SPARC Enterprise™ M4000/M5000 Servers Product Notes

For XCP Version 1082

These product notes contain late-breaking information about the SPARC Enterprise™ M4000/M5000 servers hardware, software, or documentation that became known after the documentation set was published.

Note – Information in these product notes supersedes the information in the SPARC Enterprise M4000/M5000 servers documentation set.

FIGURE 8-6 Sequence of Fixing the PCI Card in Position

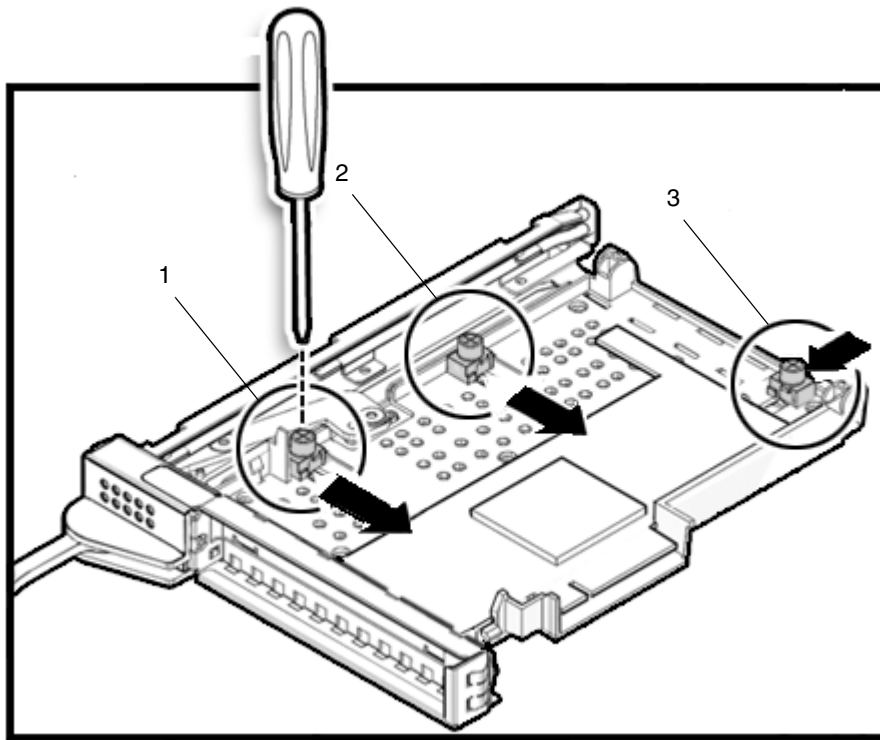
This is to correct step 4 in Section 8.2.2, "Installing the PCI Card" on page 8-9.

4. Slide the adjustable stops into position against the PCI card to hold it in place and secure them with a screwdriver.

Note – The adjustable stops should be snug against the card and securely tightened to ensure the card seats correctly. Also, fix the PCI card in position by following the 1-2-3 sequence in FIGURE 8-6.

FIGURE 8-7 I/O Unit DC-DC Converter, DC-DC Converter Retainer, and DC-DC Converter Riser Location

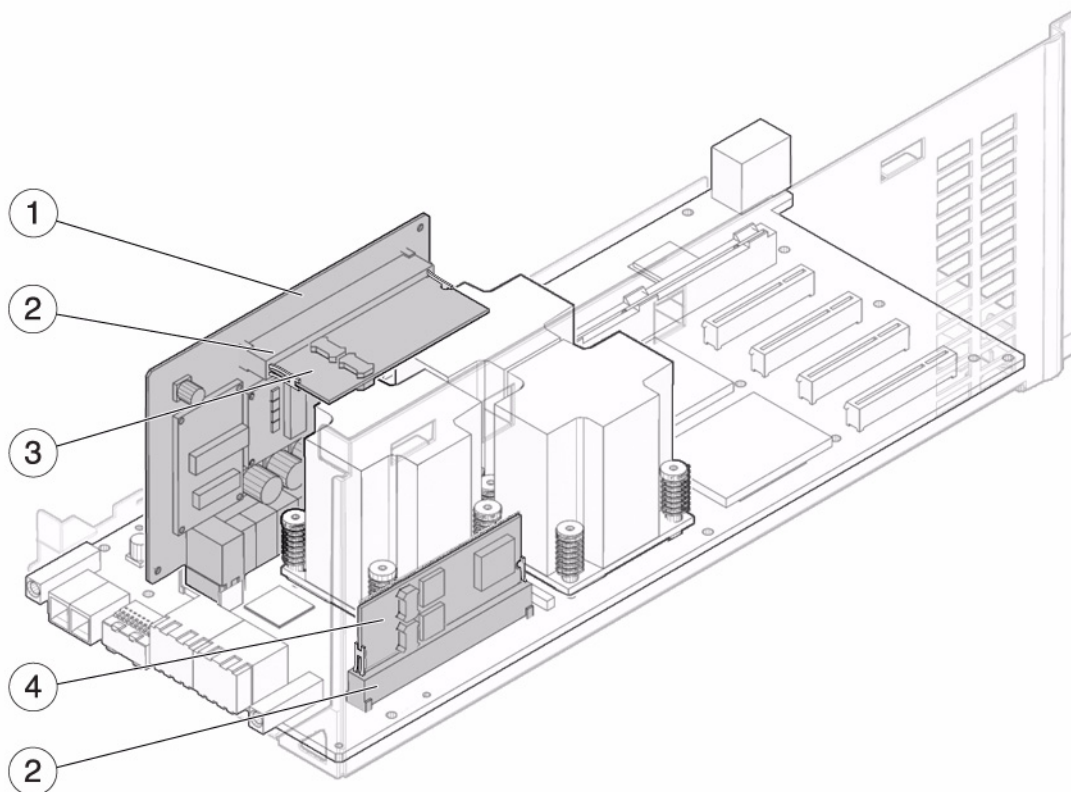
This is to correct the description in Section 8.4, "I/O Unit DC-DC Converter Replacement" on page 8-14.

The DC-DC converters are cold replacement components. This means the entire server must be powered off and the power cords disconnected to replace a DC-DC converter on the I/O unit.

[FIGURE 8-7](#) shows the location of the I/O unit DC-DC converter, the DC-DC Converter Retainer, and the DC-DC Converter Riser.

FIGURE 8-10 Installing the DC-DC Converter

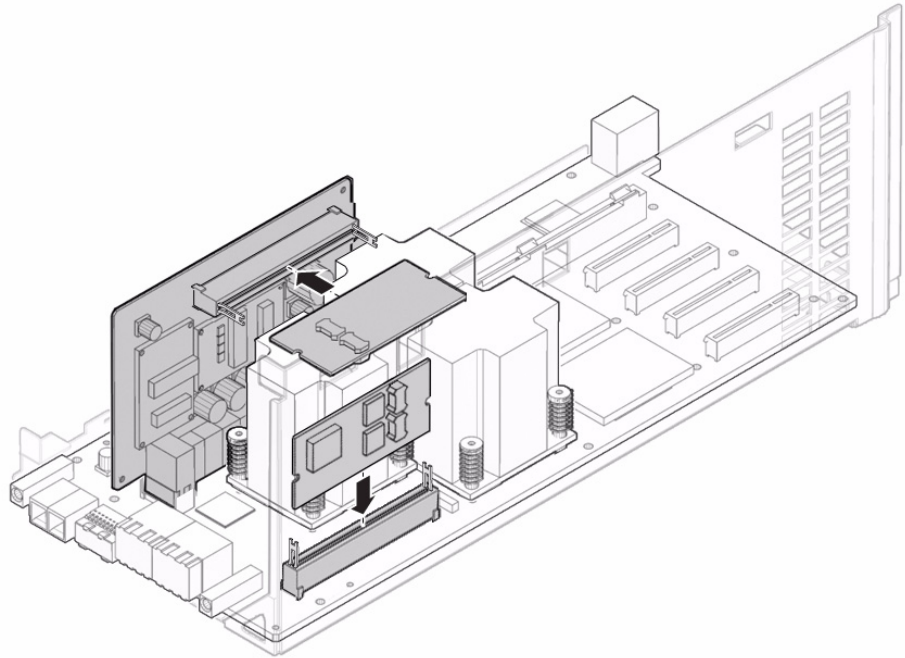
This is to correct the description in Section 8.4.3, "Replacing the I/O Unit DC-DC Converter (DDC_A #0 or DDC_B #0)" on page 8-18.

- If your server does *not* have a label covering part of the I/O unit DC-DC converter, go to [Step 1](#).
 - If your server *does* have a label covering part of the I/O unit DC-DC converter, start from one corner of the label and peel the label free of the I/O unit DC-DC converter. The label can be re-used on the replacement I/O unit DC-DC converter.
1. Disengage the old DC-DC converter from the slot.
 2. Insert the new DC-DC converter in the slot ([FIGURE 8-10](#)).

3. Push gently downward to seat the DC-DC converter.

Note – If the DC-DC converter is seated in a DC-DC converter retainer, ensure that the side clips on the retainer are attached to the side notches on the DC-DC converter.
